# UNITED STATES PATENT AND TRADEMARK OFFICE

10/587,733

<b>Office Action Summary</b>	<b>Application No.</b> 10/587,733	<b>Applicant(s)</b> FENTON ET AL.	
	<b>Examiner</b> MATTHEW LAWSON	<b>Art Unit</b> 3775

## DETAILED ACTION

FIGURE 2

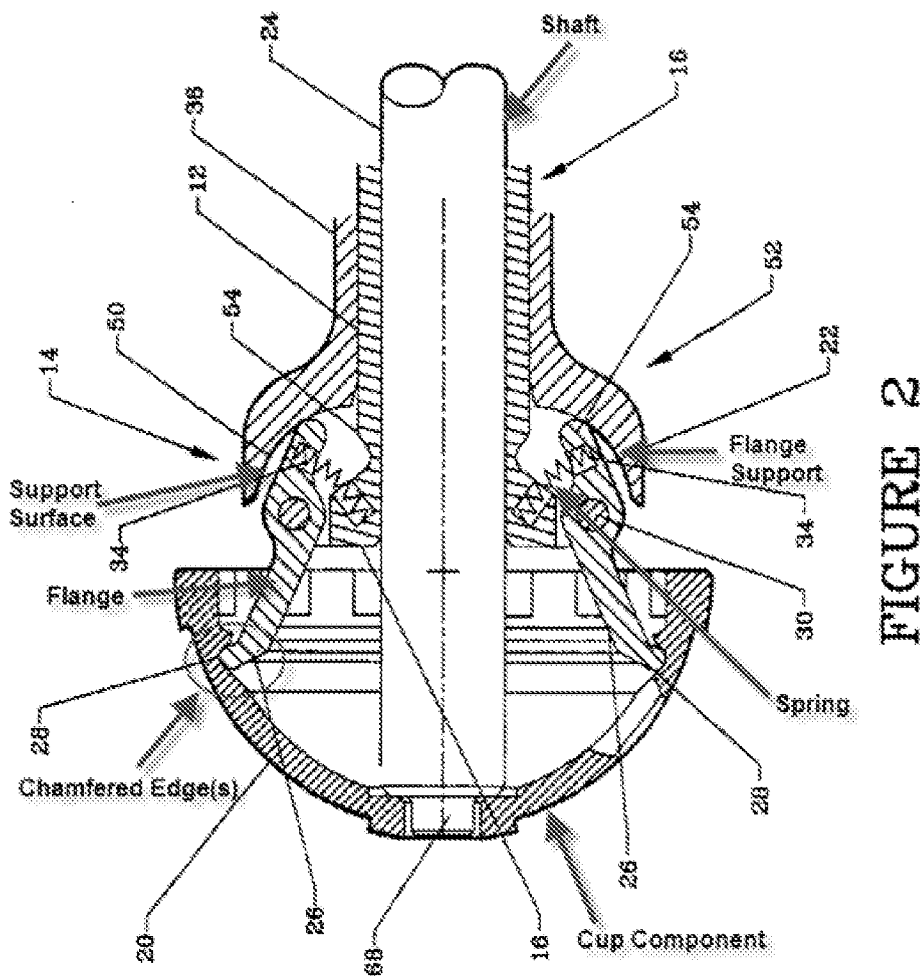
Rehmann et al. disclose an instrument for positioning a cup component of an orthopedic joint prosthesis, having a shaft (see figure below), and a flange (see figure below) towards the end of the shaft on which the cup component (see figure below) can be fixed, which extends from the shaft transversely, and which can be retracted from an in-use position (figure 2) in which the flange can be received in a groove in the internal surface of the cup component, when positioned over the end of the instrument, and a retracted position (figure 3) in which the flange is withdrawn towards the axis of the shaft from the in-use position, allowing the cup component to be released from the instrument, in which the instrument includes a transverse support (see figure below)

which extends generally parallel to the flange, and in which the flange comprises at least two radially spaced apart flange portions (figure 4), at least one of the flange portions being retractable as specified above while being supported by the support, the movement of the retractable flange portion between the retracted and in-use positions being in a direction which is parallel to the support, the retractable flange portion being biased towards the in-use position. The support presents a pair of opposite support surfaces (see figure below) and the retractable flange portion slides between them, and the support presents a support surface which the side of the retractable flange portion facing towards the end of the instrument can slide against (figures 2 and 3). The device has at least three radially spaced apart flanges (figure 4) and a cup component of a joint prosthesis (see figure below).
